**BEFORE THE PUBLIC UTILITY COMMISSION
OF OREGON**

UM 2011

General Capacity Investigation

RENEWABLE ENERGY
COALITION’S COMMENTS ON
STAFF’S CAPACITY VALUE BEST
PRACTICES UPDATED DRAFT

Figure 1: Wind non-renewable annual QF avoided cost payments at hypothetical 37.2% capacity factor

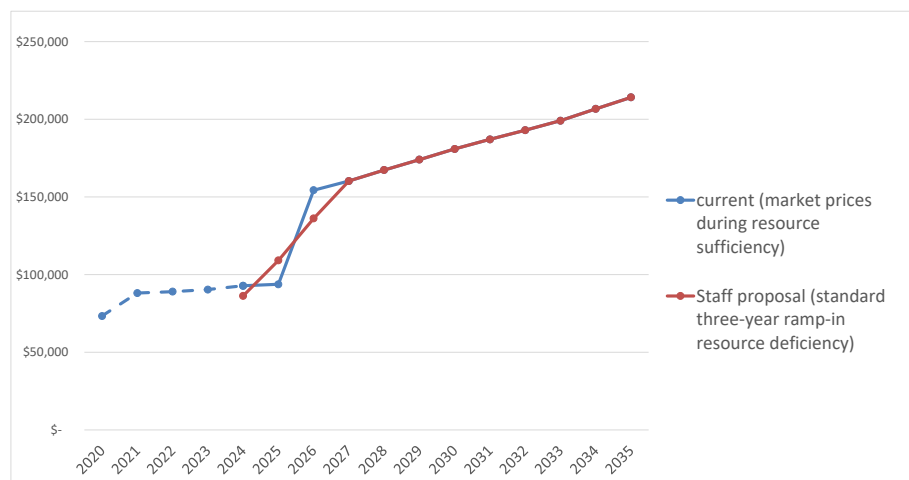
Commented [A6]: The Renewable Energy Coalition understands this Appendix to provide an illustrative capacity value example based on Staff's straw proposal. The Coalition is not revising the example, but it maintains all of its suggestions above.
